### PLANNING COMMISSION REGULAR MEETING AGENDA

<b>400 Sixth Street</b>	<b>June 1, 2026</b>	<b>7:00 PM</b>
-------------------------	---------------------	----------------

**Subject:** **322-326 Albertson Street/GH Longevity Rochester; Site Plan and Special Project Review**; Site Plan dated April 9, 2026, updated on May 5, 2026, and supplementary materials.

**1 PROPOSED SITE PLAN**

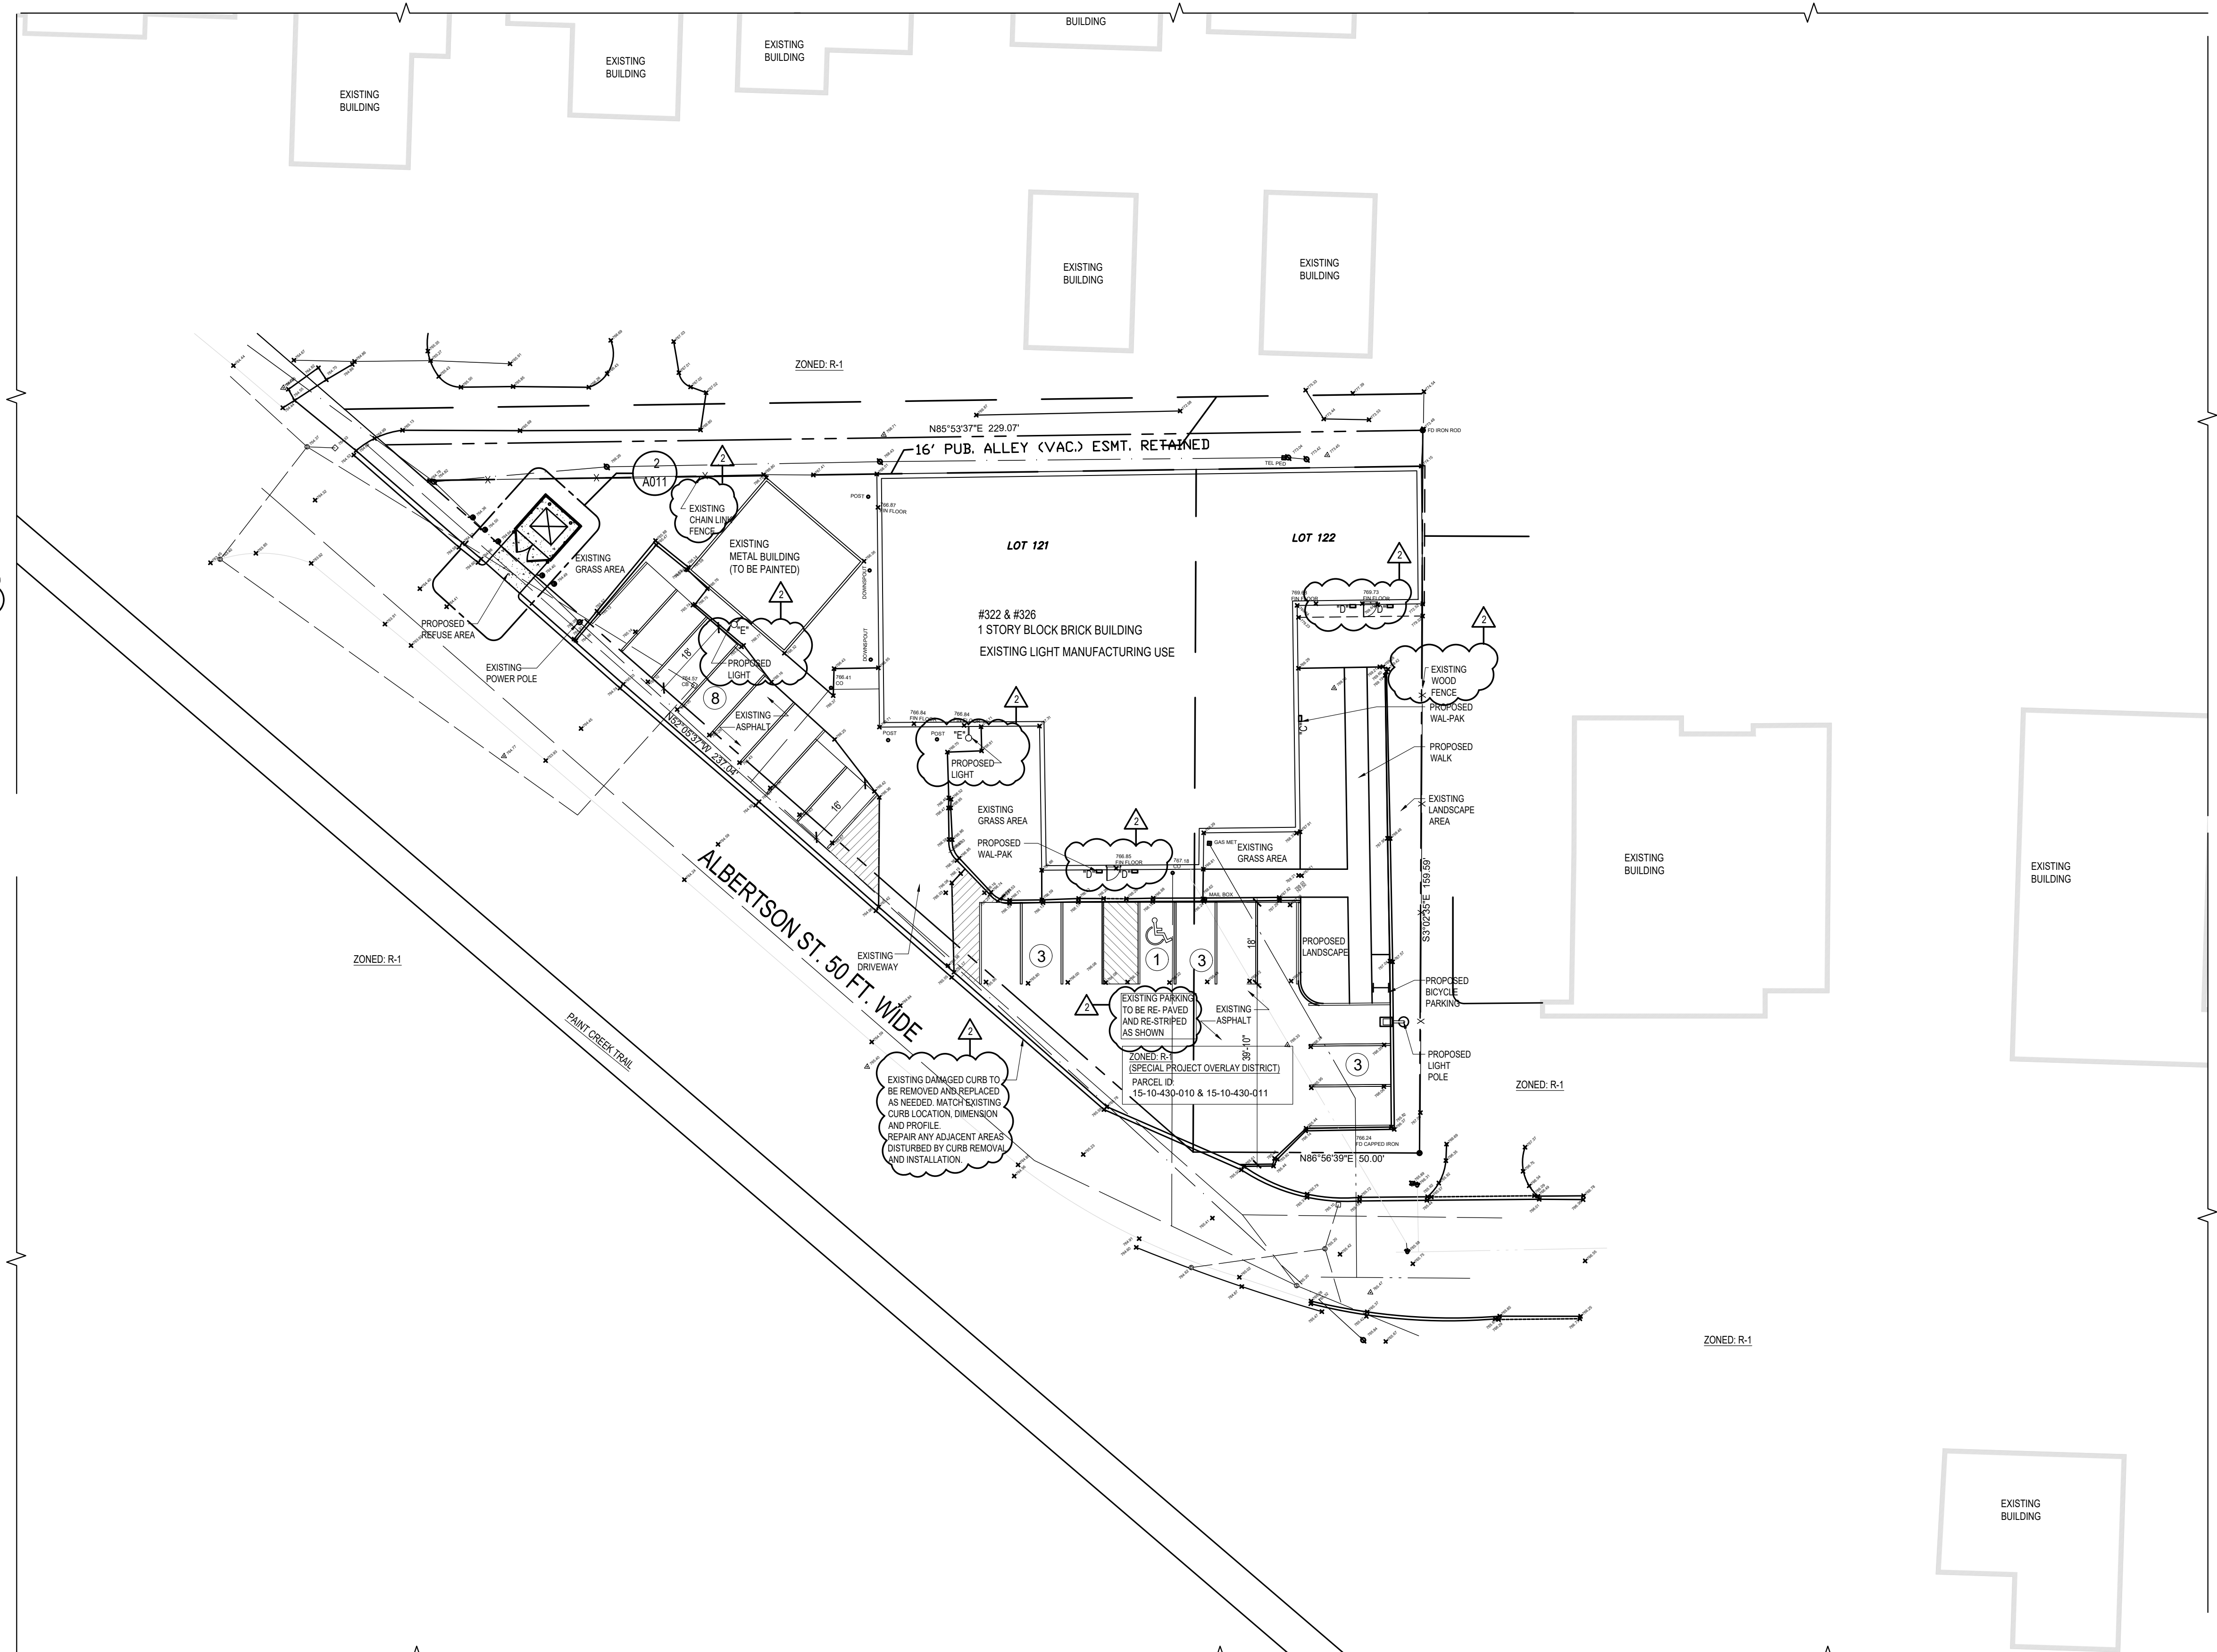
The narrative provided indicates that no exterior lighting will be provided. However, the site plans indicate existing and new lighting, and a photometric plan is included. Please provide additional details related to the proposed green wall and intended maintenance plan, as well as plans for the proposed mural. Please provide a detail showing the proposed screening materials for the relocated refuse area.

4. **Off-Street Parking.** The plans indicate an off-street parking calculation for the site requiring one space per four persons based on the maximum capacity and one space per employee on the largest employment shift. Based on a maximum capacity of 56 persons and the maximum number of employees at any given time being four, 18 spaces would be required on the site. Eighteen off-street spaces are provided on the site, including one ADA compliant space. The spaces are compliant with the required dimensions and the parking area will be repaved as part of the improvements.

- **Screening.** Screening is required between this non-residential use and neighboring residential uses. Section 2804 requires a masonry wall. However, provides the Planning Commission with the option to approve dense vegetation as an appropriate screen, which would allow the existing screening to be maintained. The heights of the existing fences were not provided. If approved by the Planning Commission they may be maintained as is, but it should be confirmed if the fences are an existing non-conformity to better understand how they should be treated moving forward.

1 LANDSCAPE PLAN  
A012 SCALE: 1" = 20'-0"

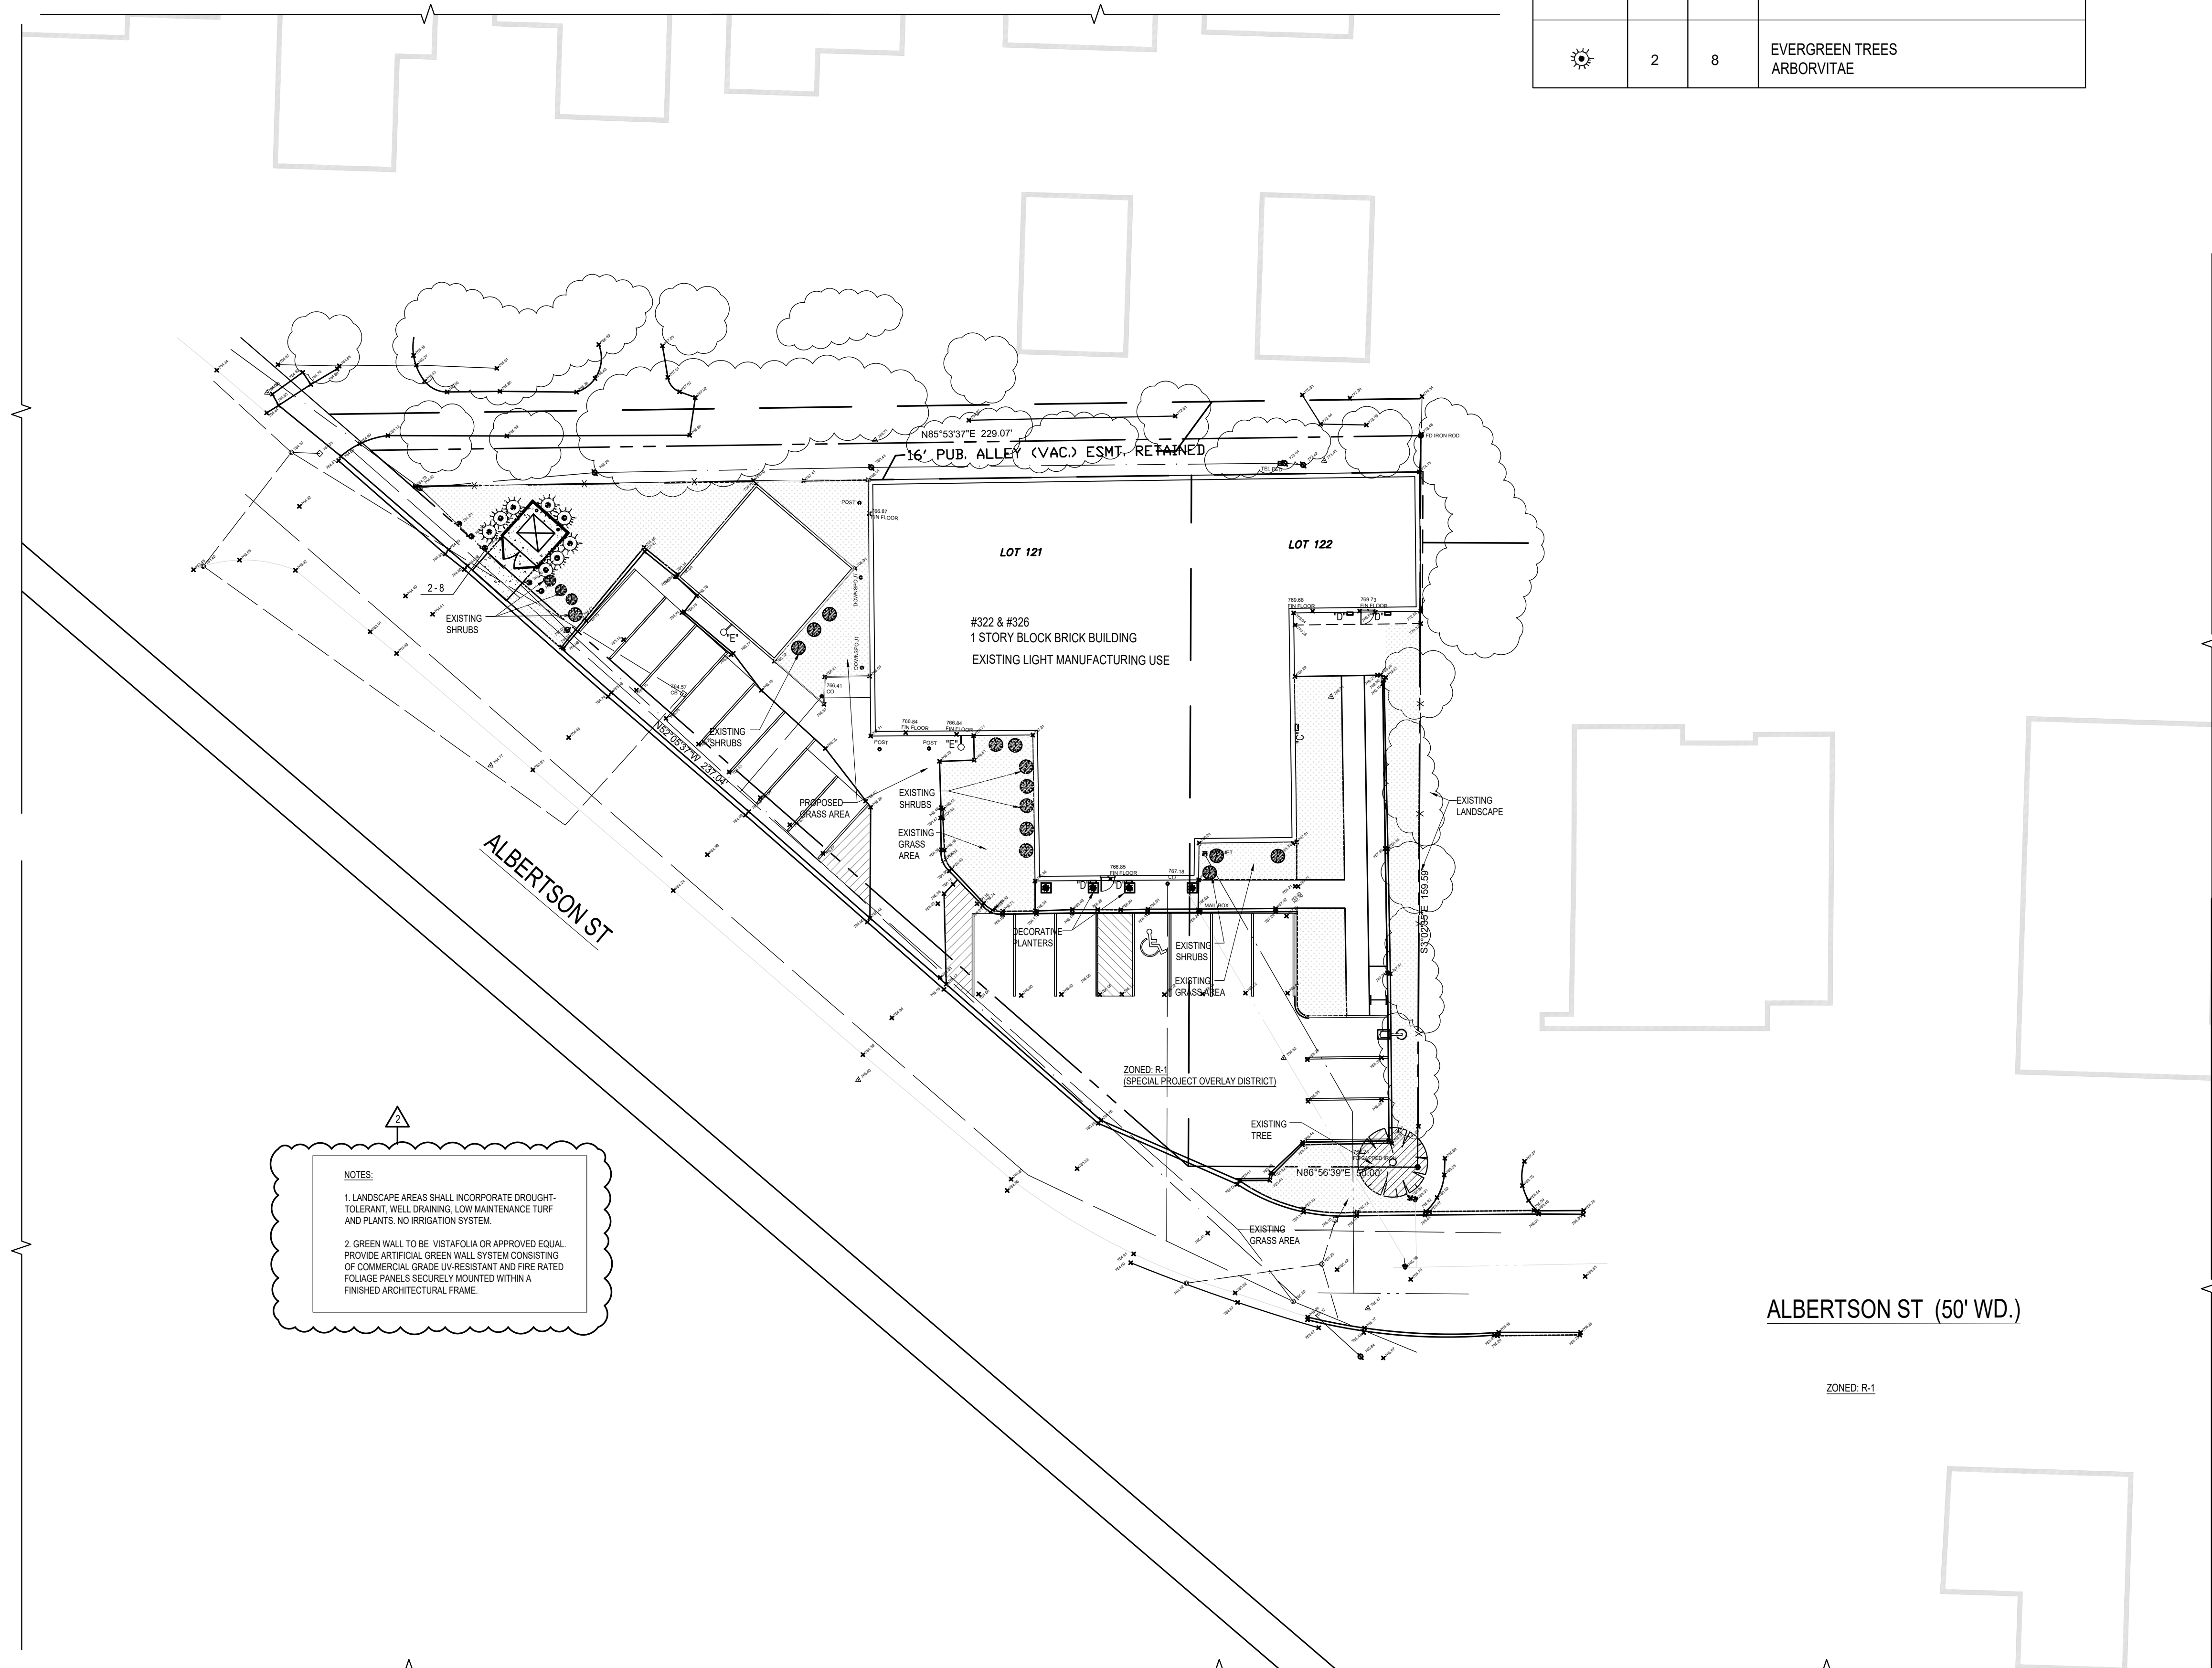
- **Landscaping.** The landscaping plans preserve the existing tree on the site and adds 8 trees, as well as several shrubs to provide additional screening and add to the overall site aesthetic. The landscape plan complies with Section 2800 of the ordinance.

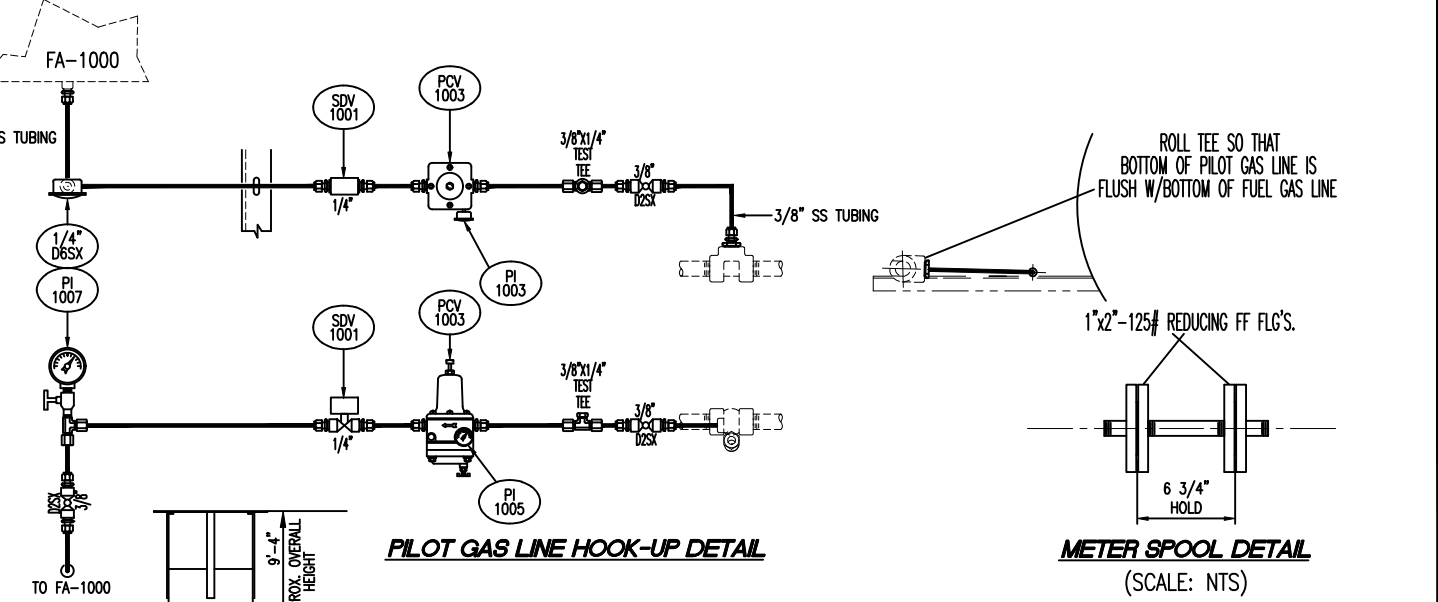
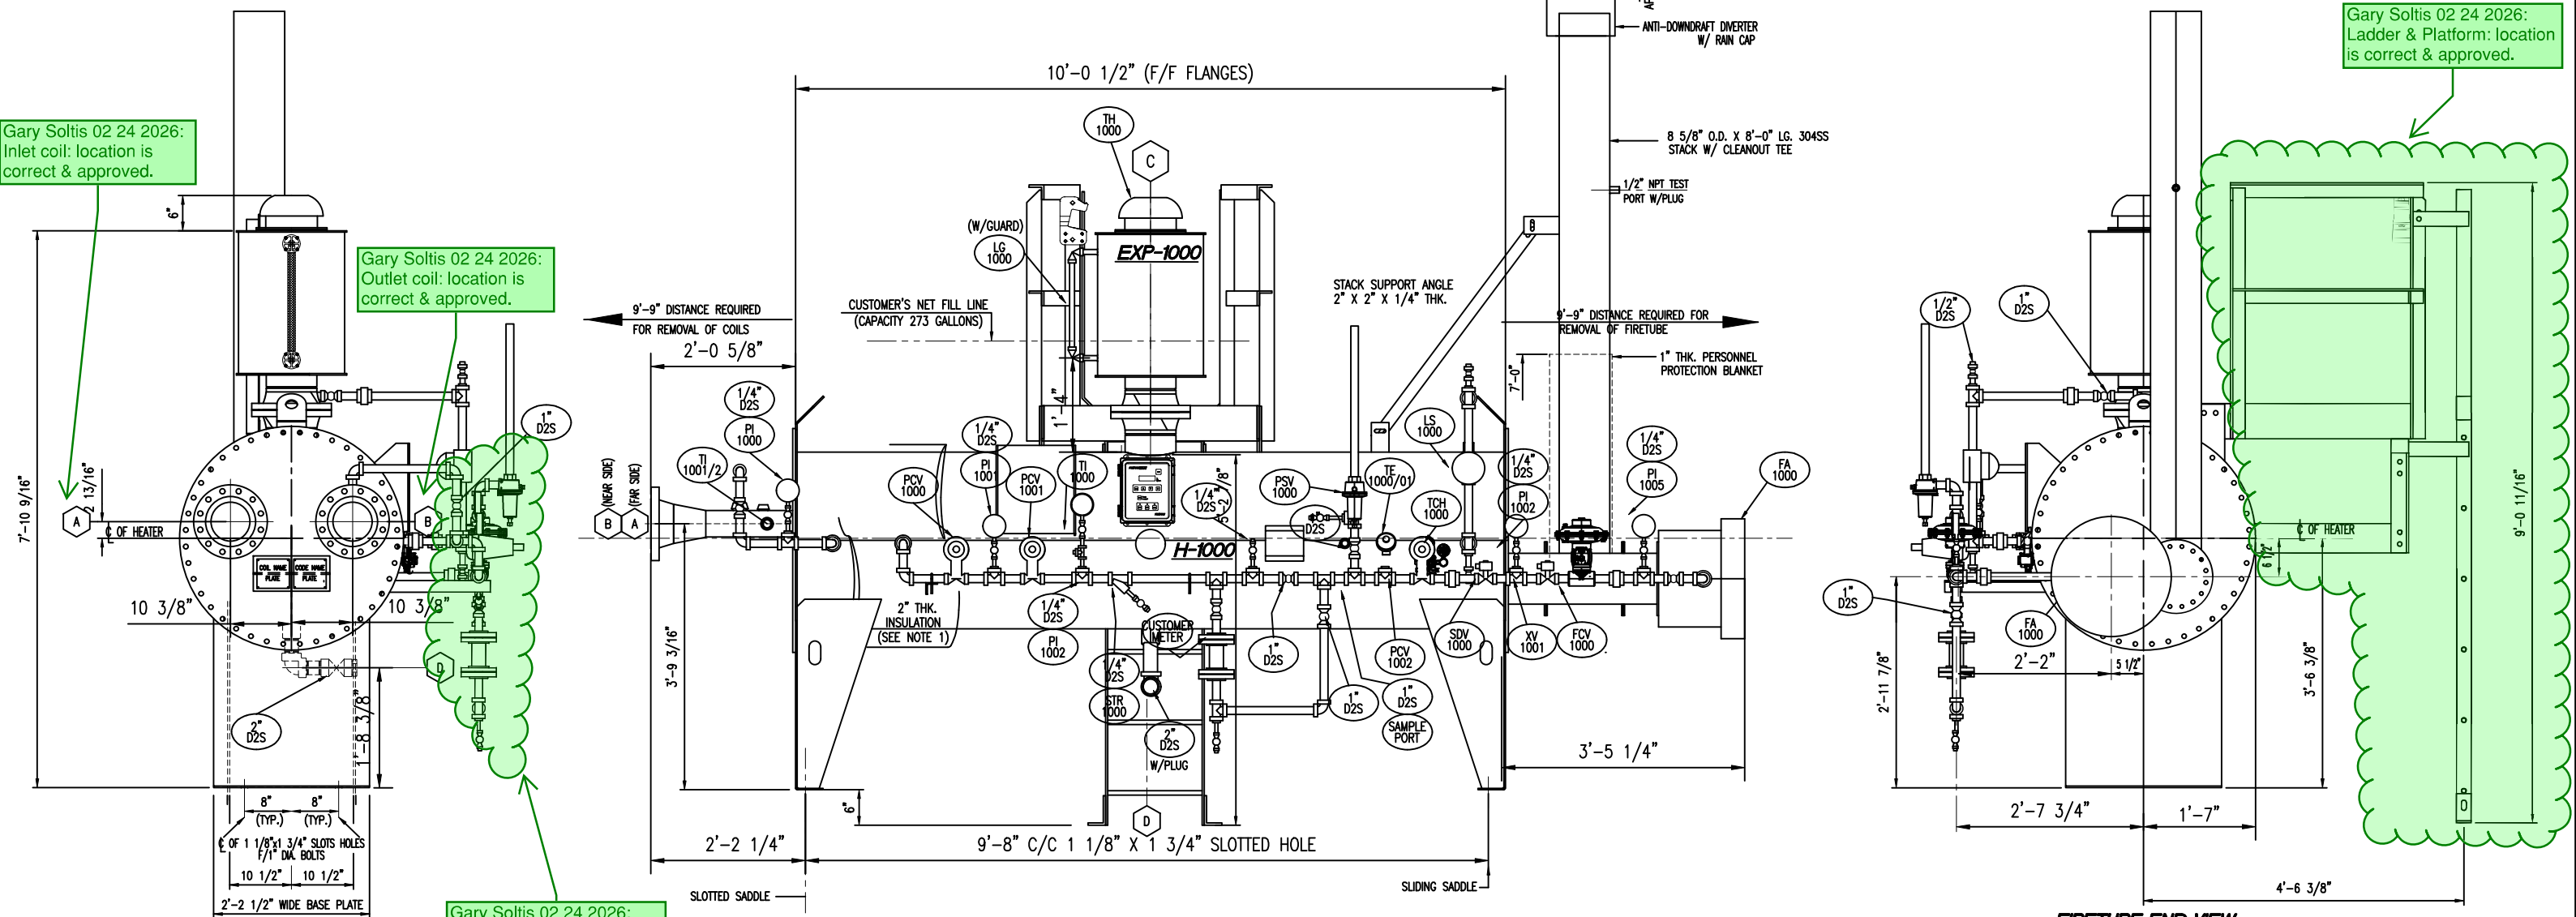
Gary Soltis 02 24 2026:  
Inlet coil: geometry is correct & approved.

Gary Soltis 02 24 2026:  
Outlet coil: location is correct & approved.

Gary Soltis 02 24 2026:  
Ladder & Platform: location is correct & approved.

**APPROVED BY: CONSUMERS ENERGY - GARY SOLTIS 02 / 26 / 2026**
